MCPB
1/22/98
Item #9

MEMORANDUM

DATE: January 16, 1998
TO: Montgomery County Planning Board
FROM: Wynn E. Witthans, ASLA, AICP *W*
 Development Review
 Planning Department Staff
 (301) 495-4584
VIA: Charles Loehr, Chief, *CL*
 Development Review
REVIEW TYPE: Site Plan Review
APPLYING FOR: 768 units: 75 SFD, 295 Townhouses, 398 multifamily inclusive of 96 MPDU's
PROJECT NAME: Clarksburg Town Center - Phase I
CASE #: 8-98001
REVIEW BASIS: 59-D-3 of the Montgomery County Code is required for the optional method of development in this zone.
ZONE: RMX-2, Residential Mixed Use Development, Specialty Center
LOCATION: Northeast of the intersection of Clarksburg Road and Stringtown Road
MASTER PLAN: Clarksburg Master Plan and Hyattstown Special Study Area, June 1994
APPLICANT: Clarksburg Land Associates L.P. and Piedmont Land Associates L.P. and T/A Clarksburg Town Center Venture
FILING DATE: August 1, 1997
HEARING DATE: January 22, 1998

SECTION IA & IB
CLARKSBURG TOWN CENTER
CLARKSBURG (AND ELECTION DISTRICT)
MONTGOMERY COUNTY, MARYLAND

Applicant's Proposal 30

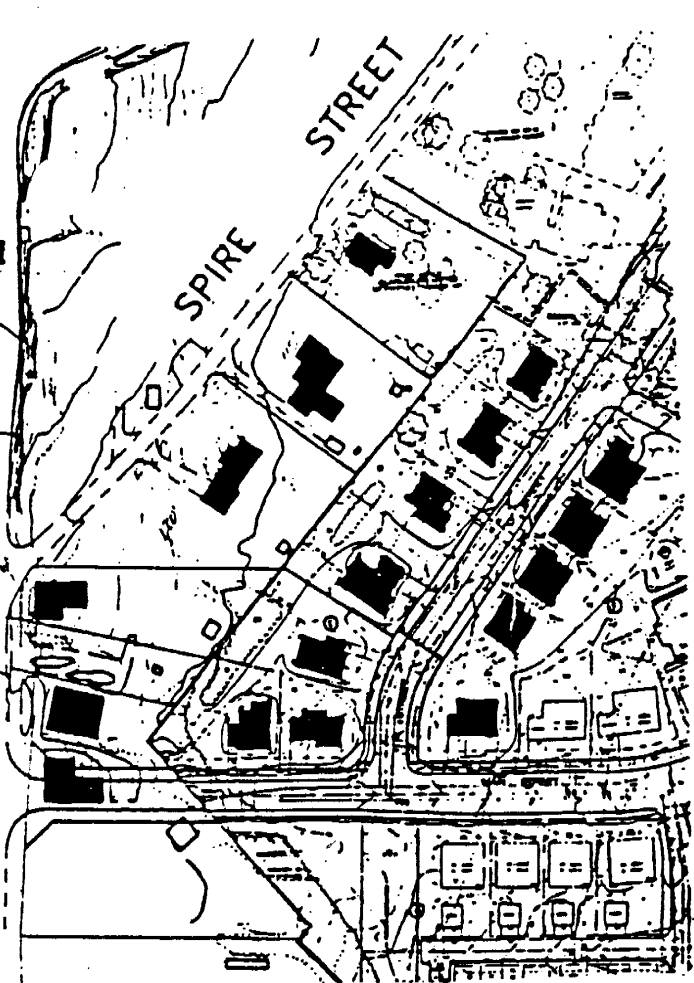
In the context of the site plan review, the HPC reviewed the project and found several requirements outstanding and has passed on the following recommendations: a 20 ft setback, free of a public utility easement, from the right-of-way to the historic Day house at the corner of MD 355 and Stringtown Road; appropriate lighting on Stringtown Road to be compatible with the Historic District; the CTC developer and Aric Ruddin should continue to resolve their issues to allow the Main Street connection to occur opposite Redgrave Place; a detailed design for a public space/interpretative area

The removal of a proposed house is to create compatibility between the two projects utilizing similar scaled and dimensioned buildings and surrounding open spaces. The existing condition on Spire Street has three homes that have lot widths at their building face of 130 ft, 115 ft and 180 ft. The lots along MD 355, whose rear yards adjoin the common boundary, have 40 and 60 foot widths at the front building line. The proposed six lots have 2 lots with 68 foot widths at the front building line, one lot at 65 feet, one lot at 990 feet, one lot at 88 feet and one lot at 120 feet. The average frontage for all six lots is 83 feet. The approved Project Plan condition reads: "...the size of lots and setbacks of the proposed development must match, approximately, the development standards in the R-200 Zone for building setbacks and width of lots along the southeastern boundary of the site..." The required lot width along the front building setback line is 100 feet. The dimensions of the proposed lot widths and the sketch below show the lack of conformance with the desire of the HPC and the Planning Board's earlier decisions. The staff proposal clearly shows that the 100 foot lot widths work to create an appropriate transition between the existing Historic District and the proposed units. See memo of January 15, 1998 from the Historic Preservation Commission in the Appendix.

Staff's Recommendation

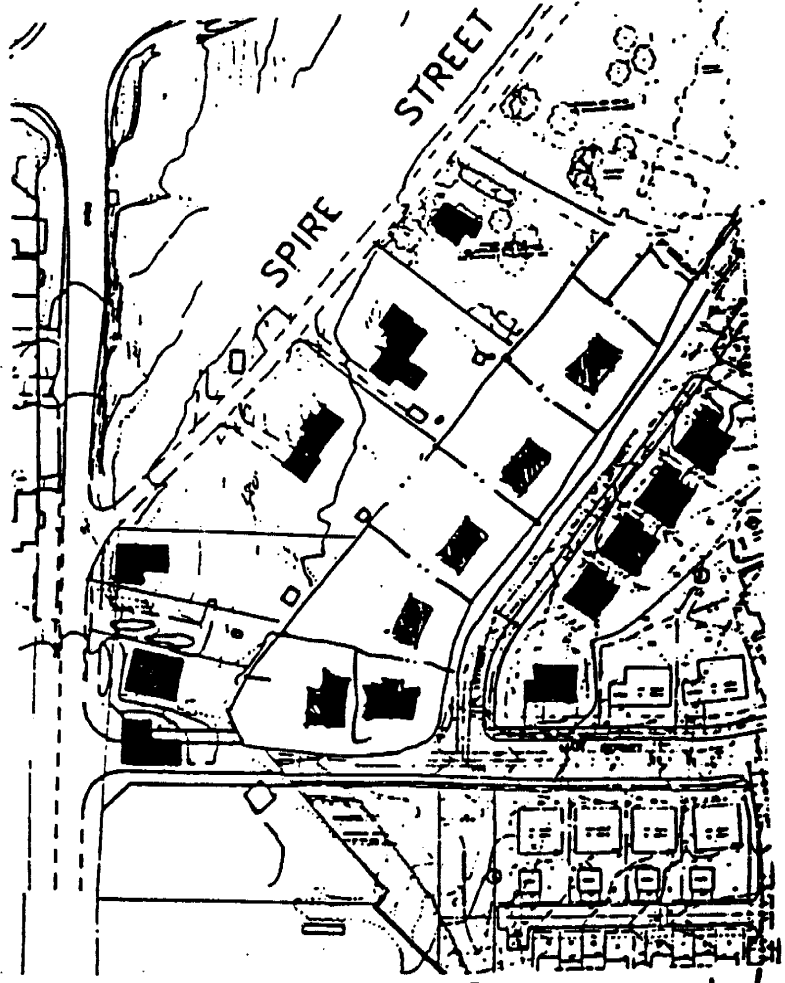
32. One lot should be deleted from the single family home area directly adjacent to the Historic District, to fulfill the Project Plan condition to approximate R-200 zone lot width standards.
